**Landscape Review Committee**  
**Community Development Center, 231 NE 5<sup>th</sup> Street**

**July 1, 2020 - 12:00 PM**

DATE: July 1, 2020  
TO: Landscape Review Committee Members  
FROM: Jamie Fleckenstein, Associate Planner  
SUBJECT: Agenda Item 4A – Landscape Plan Review Application (L 11-20)

**DECISION, CONDITIONS, FINDINGS OF FACT AND CONCLUSIONARY FINDINGS FOR THE  
APPROVAL OF A LANDSCAPE PLAN REVIEW FOR 2515 NE ORCHARD AVENUE**

**Figure 5: Proposed Landscape Plan**

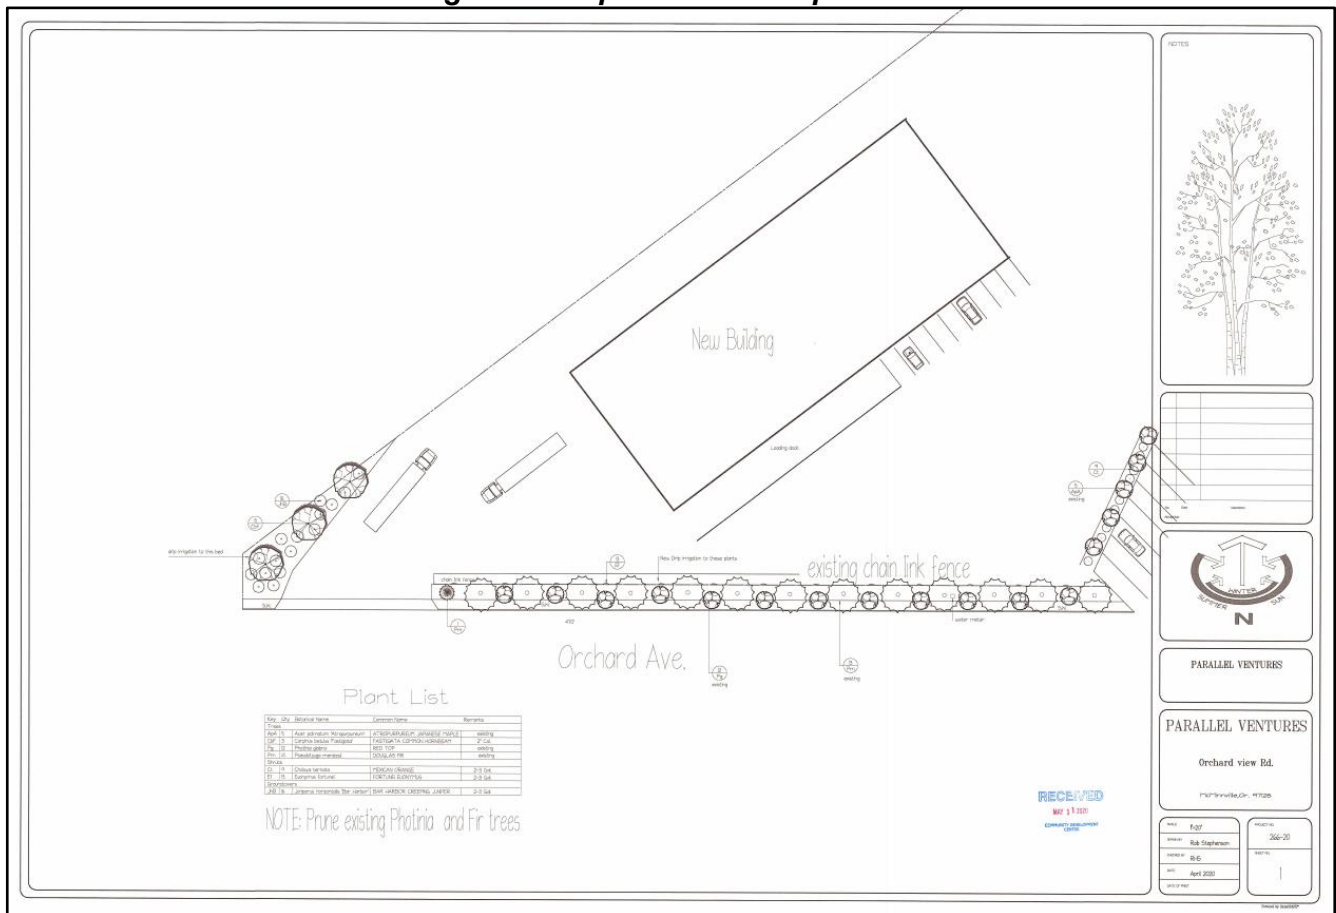
**FINDING: SATISFIED WITH CONDITION #2.** The site plan features an approximately 25,000 square foot industrial building in the southwestern portion of the subject site, adjacent to NE Orchard Avenue and the railroad tracks. The site is accessed from Orchard Avenue near the railroad crossing, and off-street parking and loading is located adjacent to the building. Street improvements along Orchard Avenue adjacent to the development area will include new curb, gutter, and sidewalk. The landscape plan addresses landscaping for the site entry near the driveway, the adjacent right-of way along Orchard Avenue, and the southeastern portion of the development area adjacent to existing off-street parking.

1. That the applicant shall install landscaping as shown on the revised landscape plan received by the McMinnville Planning Department on May 11, 2020, and shall comply with required conditions of approval.
2. That a Certified Arborist shall verify that any root pruning and/or construction activity done to accommodate the new sidewalk will not impact the structural stability of the existing Douglas Fir and Photinia trees along Orchard Avenue adjacent to the development site. If the Certified Arborist determines that the stability of an existing tree is compromised and the tree is not suitable to retain, the applicant shall be responsible for removal of the tree and its replacement with a

**Figure 8: Outdoor Event Space/Parking Landscaping**

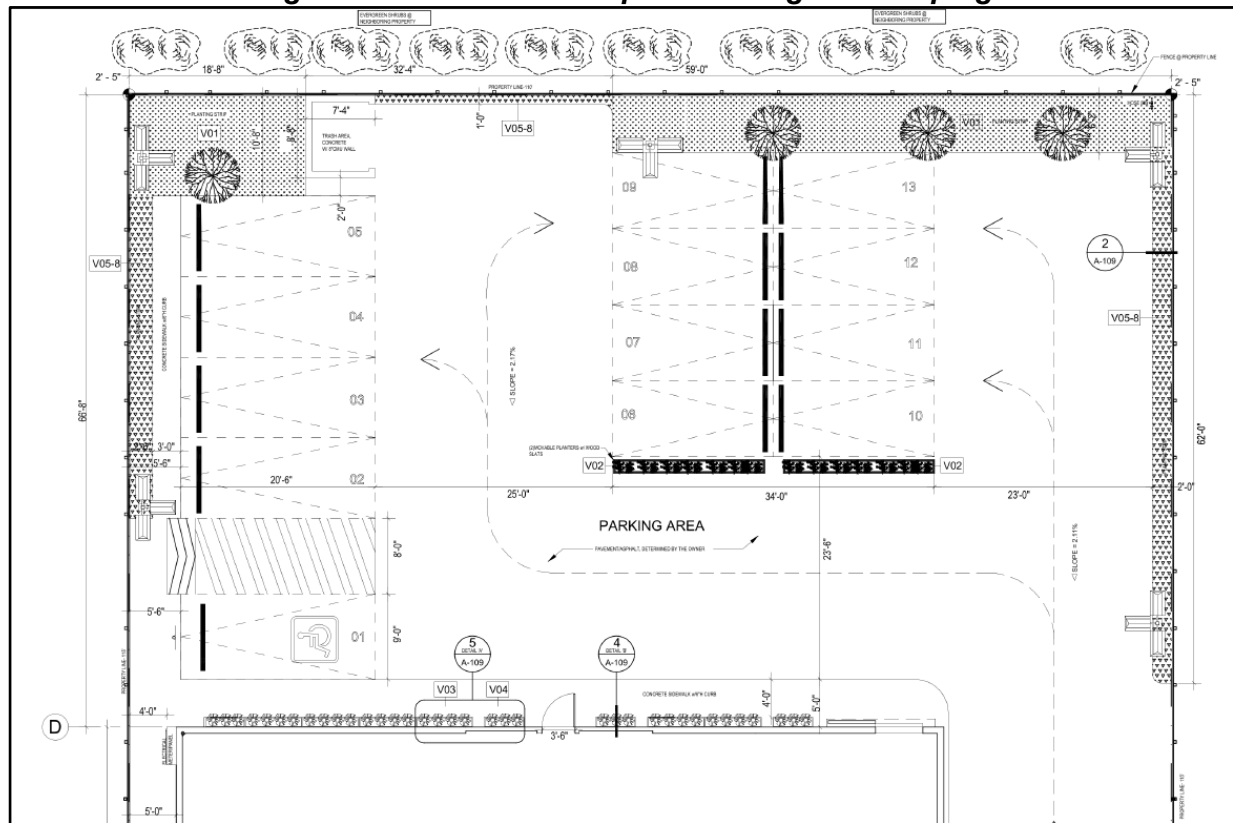
Landscaping in the front of the building along the Lafayette Avenue frontage is intended to maximize the outdoor dining while providing screening and buffering from traffic on Lafayette Avenue. **See Figure 6 (Lafayette Avenue Landscaping).** Proposed landscaping includes street trees in tree wells, and raised planters between the street trees and building planted with the flowering perennial *Veronica liwanensis* (Turkish Speedwell). The raised planters are described in the application as two (2) feet wide, approximately three (3) feet tall, and varying in length. They would be wrapped with wood trim. They are not intended to be permanently affixed, but rather movable with machinery such as a pallet jack. **See Figure 7 (Planter Detail A).** Turkish Speedwell, the proposed plant material for the planters along Lafayette Avenue, is a groundcover-like flowering perennial. Based on a study of vision clearance of north-bound traffic on Lafayette Avenue, Public Works staff also recommended preserving a clear vision area within approximately 40 feet west of the driveway. No street trees or other obstructions are proposed within the recommended clear vision area.

Landscaping around the perimeter of the parking lot consists of synthetic turf, a combination of evergreen groundcovers, and four (4) medium trees such as *Cornus nuttallii* (Pacific Dogwood). The Pacific Dogwood is a native tree that grows approximately 45 feet tall and 20 feet wide. The trees are located to provide canopy cover over the parking area that would typically be provided by trees in internal parking lot islands. Synthetic turf is proposed in the wider landscape areas along the norther property line to provide flexibility for outdoor events in the area. In the narrower landscape areas around the parking lot, a combination of evergreen groundcovers are proposed. The groundcovers include:

#### ***Proposed Landscaping around Dental Clinic***

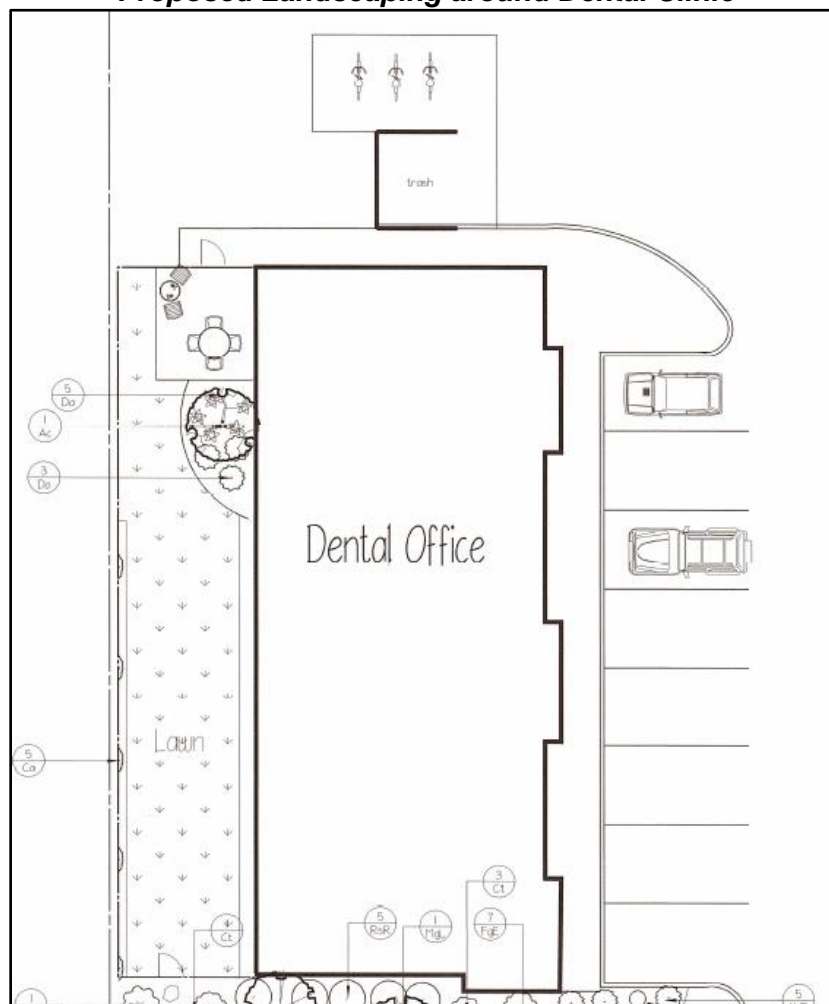
A trash enclosure is shown on the landscape plan to the north of the dental clinic, though landscaping is not proposed around the enclosure. As described in findings for Chapter 17.61 of the Zoning Ordinance below, landscaping would not be required around the trash enclosure because it is not visible from the public right-of-way in its proposed location.

Landscaping is not proposed along the front of the building, between the parking lot and entrances. A walkway provides pedestrian connection from parking spaces to the building entrances.

Proposed Landscaping Along East Property Line

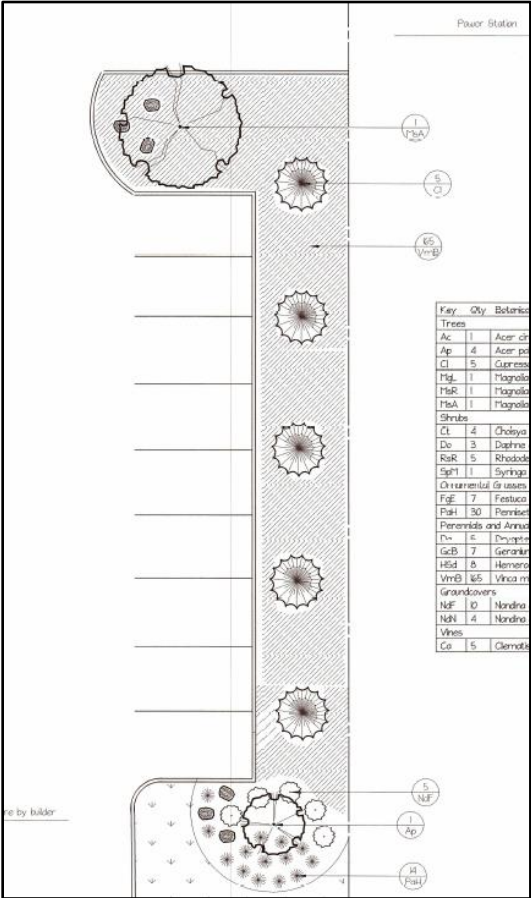
A wide landscape area is proposed along the east property line of the development site between the proposed parking area and the adjacent McMinnville Water & Light substation to the east. Evergreen *Cupressocyparis leylandii* (Leyland Cypress) trees, a deciduous *Magnolia x soulangiana* 'Alexandrina' (Alexandrina Chinese Magnolia) tree, and the evergreen ground cover *Vinca minor* 'Bowles Variety' (Bowles Variety Periwinkle) is proposed in the space.

### Site Survey with Existing Tree Locations

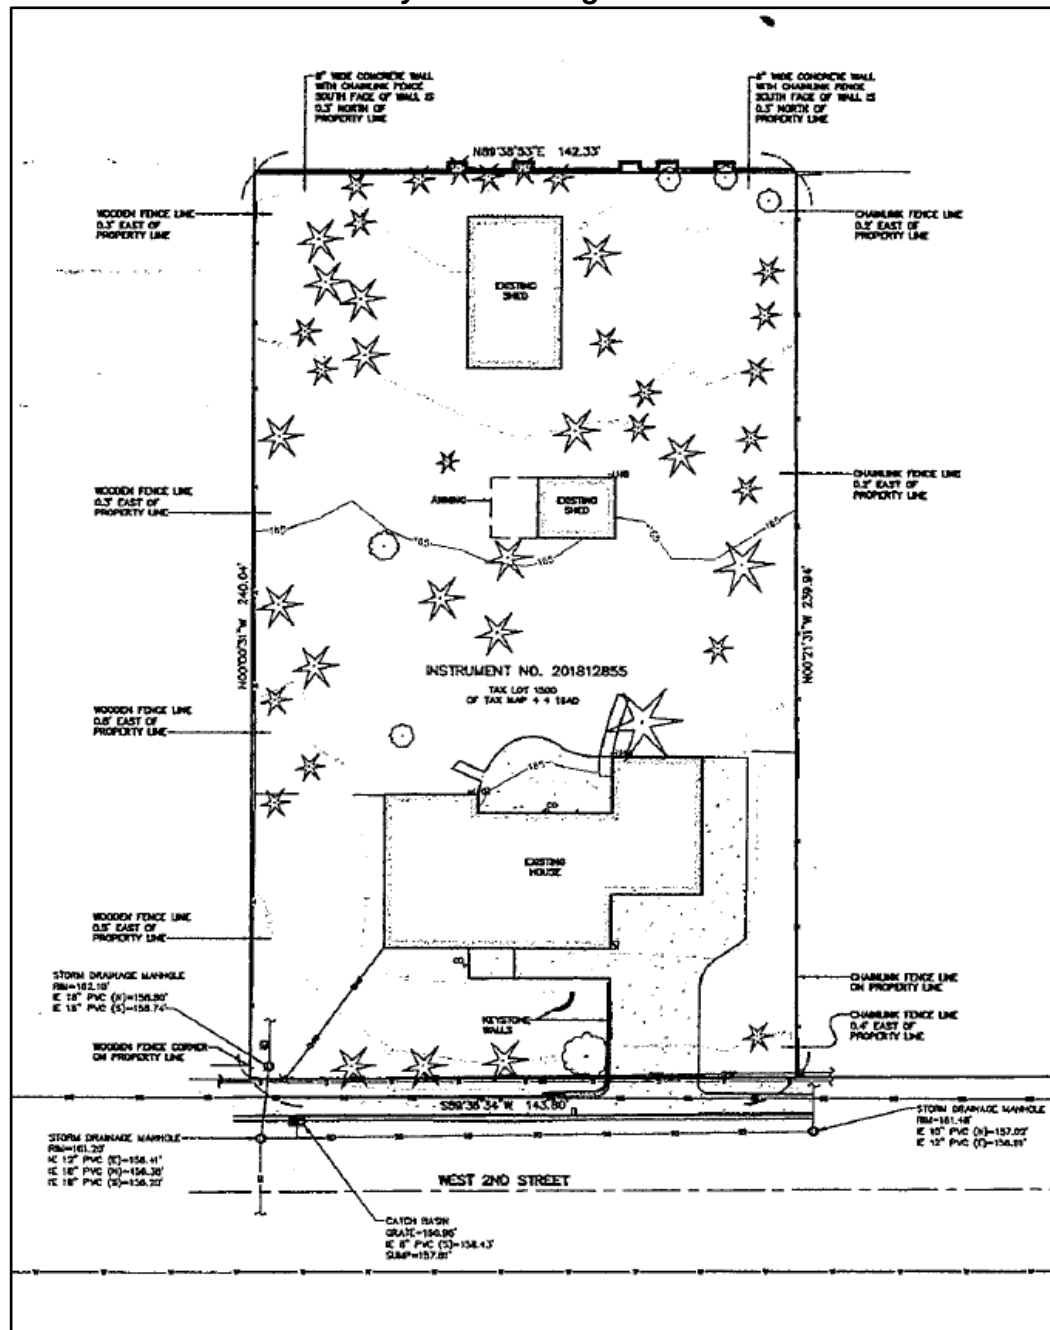
**FINDING: SATISFIED.** A site survey indicates that many existing mature trees are present on the site. In accordance with Condition of Approval #4 of ZC 4-19, an arborist report and tree inventory was provided requesting the removal of five (5) trees larger than 9" in diameter along 2<sup>nd</sup> Street. To further comply with the condition, the applicant has indicated that additional arborist reports will be provided to request the removal of trees along the west property line that may be in conflict with the proposed development. Many existing trees will remain on the northern half of the property that are not impacted by the development of the dental clinic.
